RE: **House of Life Ministries**
Quaker Heights Rd NW
Conceptual Grading Plan Stamp Date 1/2/20
Drainage Report Stamp Date: 1/2/20
Hydrology File: F11D020

Based on the submittal received on 1/7/20, this project cannot be approved until the following corrections are made:

Conceptual Drainage Report

ENGINEER'S SEAL	Title: House of Life Ministries Quaker Heights Pl. NW CONCEPTUAL GRADING AND DRAINAGE PLAN	DRAWN BY
		DATE
		Day
		SHEET #
		Appendix B
		JOB #

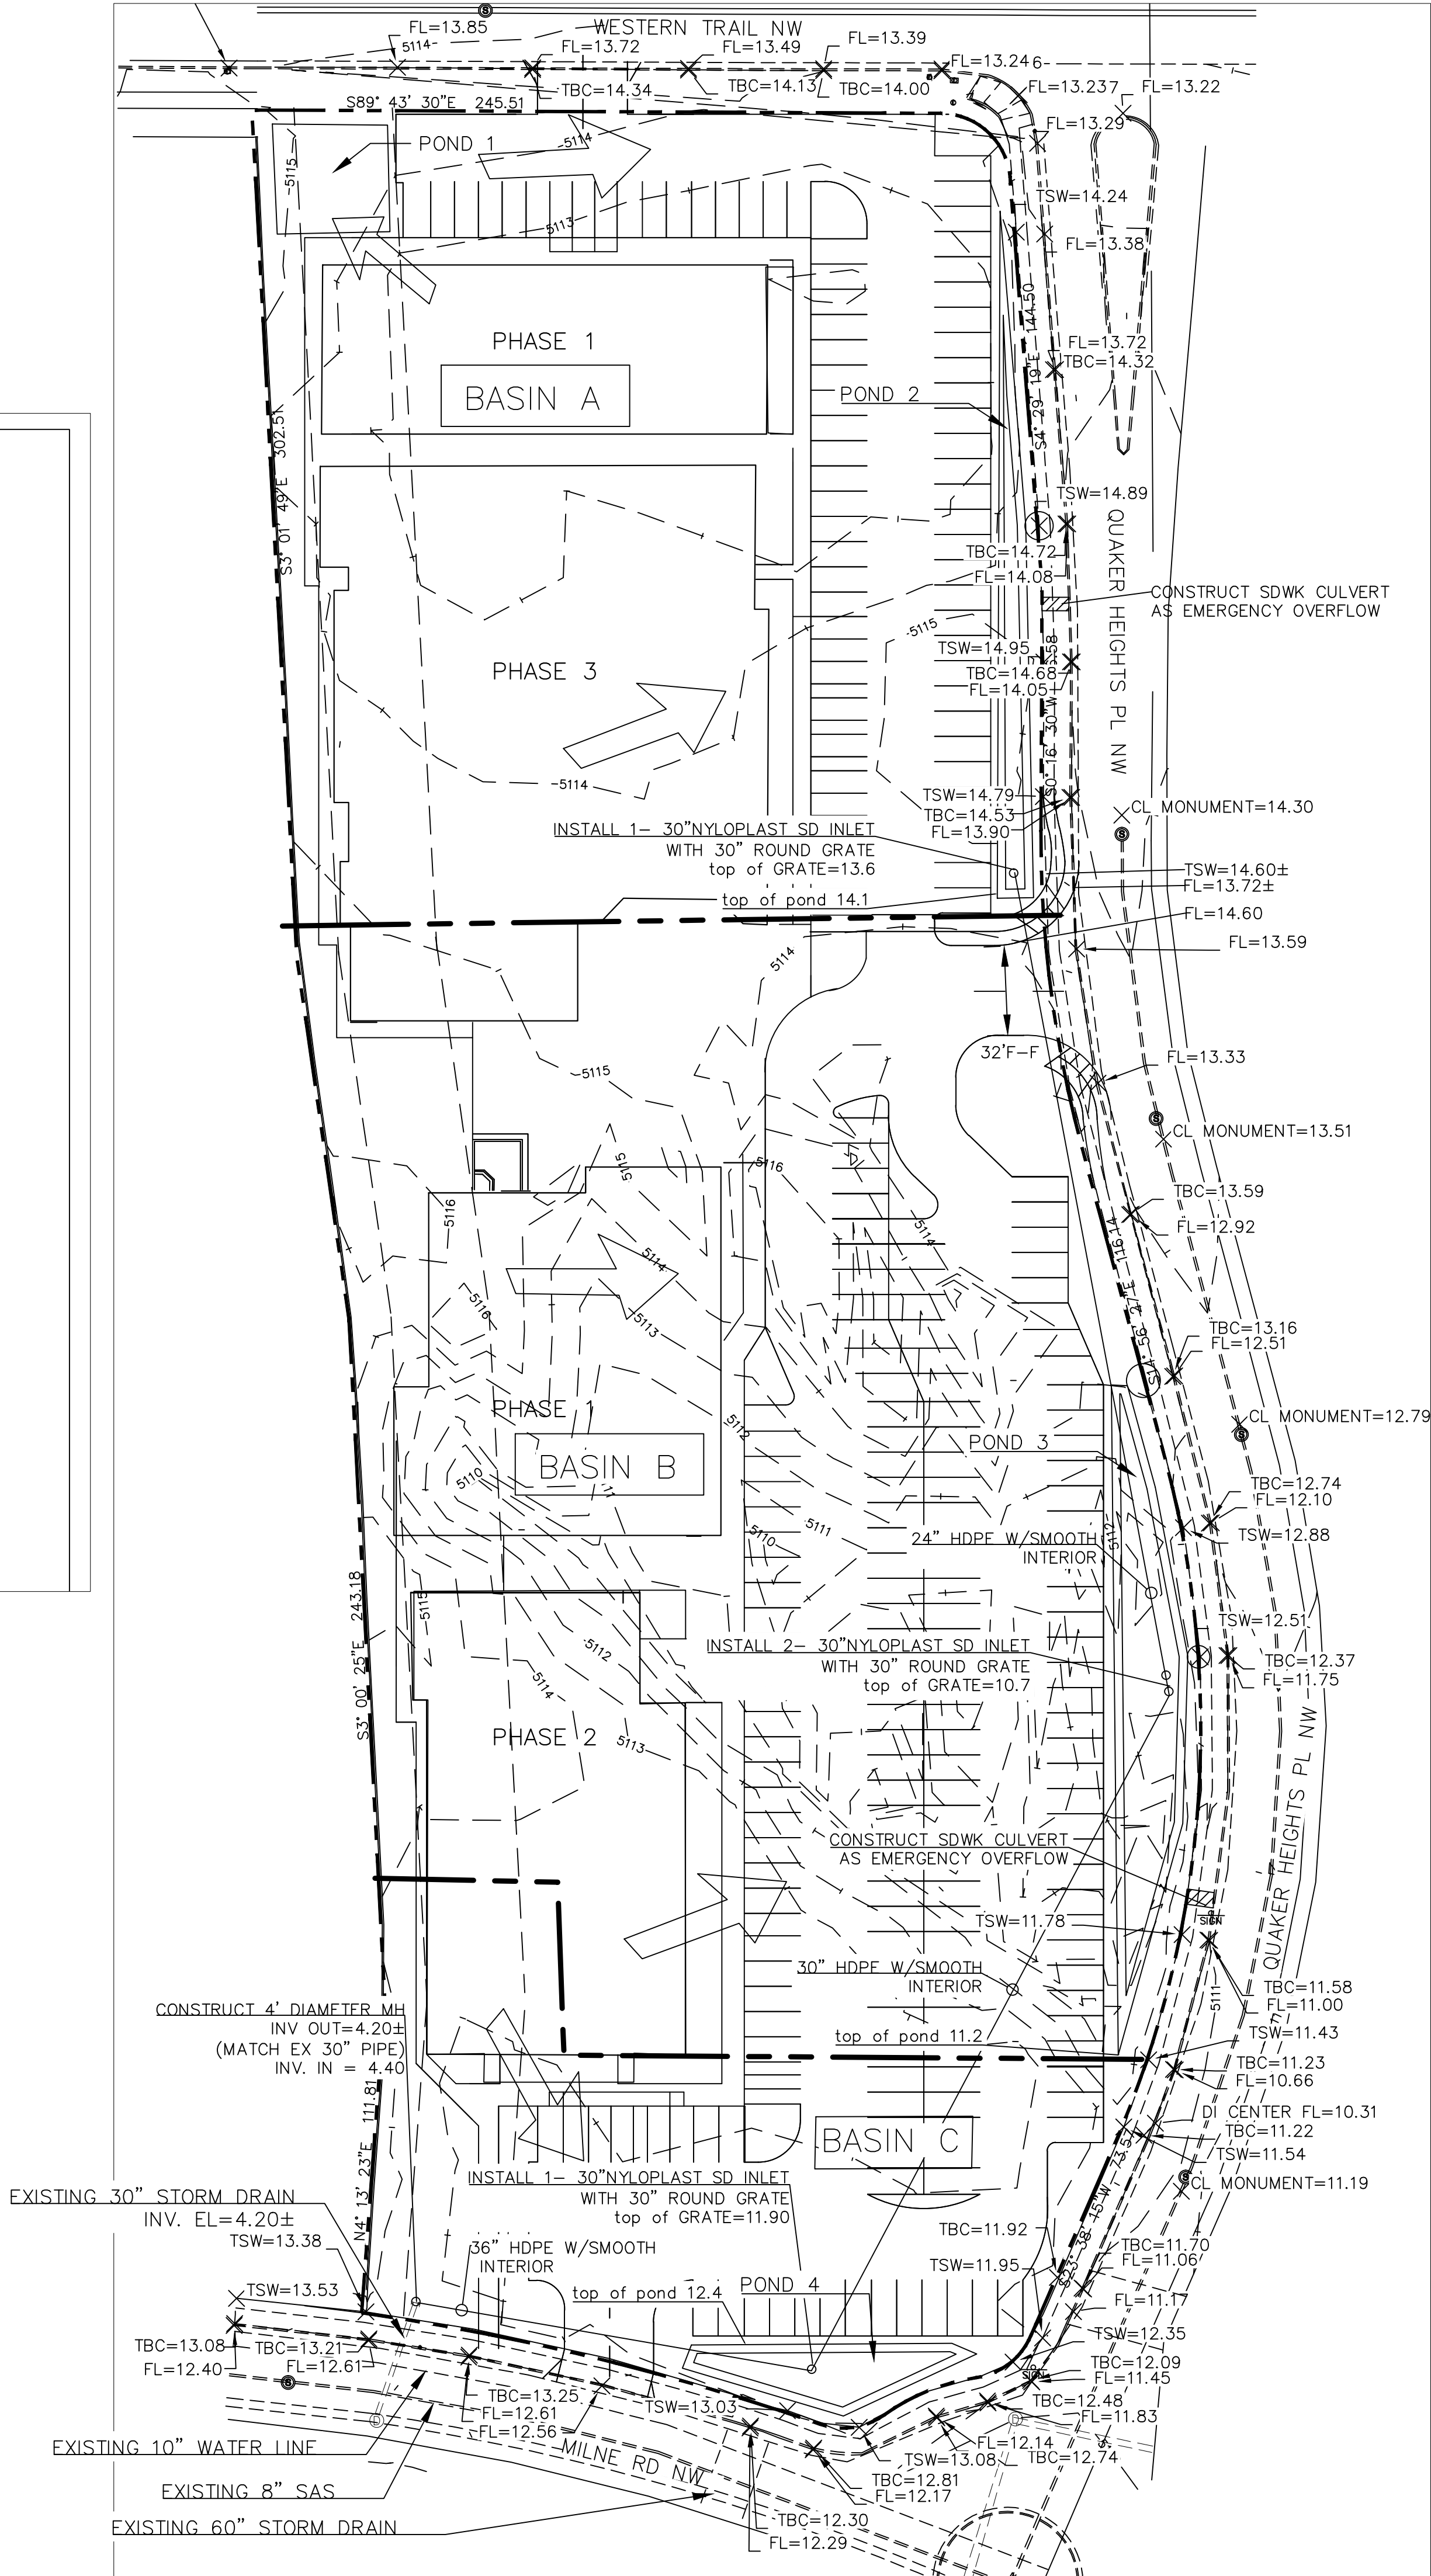
1. Will the sidewalk culvert be built by SO-19 or Work Order? Please label/provide notes as appropriate.
2. Provide proposed grading, finished floors, and spot elevations throughout the site.
3. The site must discharge in accordance with the approved master plan. Accounting for pond routing and stormwater quality volume will probably get within the allowable discharge and volume, but this analysis needs to be presented.
4. Please provide the SWQV calculations for each basin draining to each pond. The stormwater quality ponds need to be sized for the areas draining to them.
5. Please number the ponds and include a label on each with the SWQV and elevation, the 100-year volume and elevation, and the peak 100 year inflow and outflow.
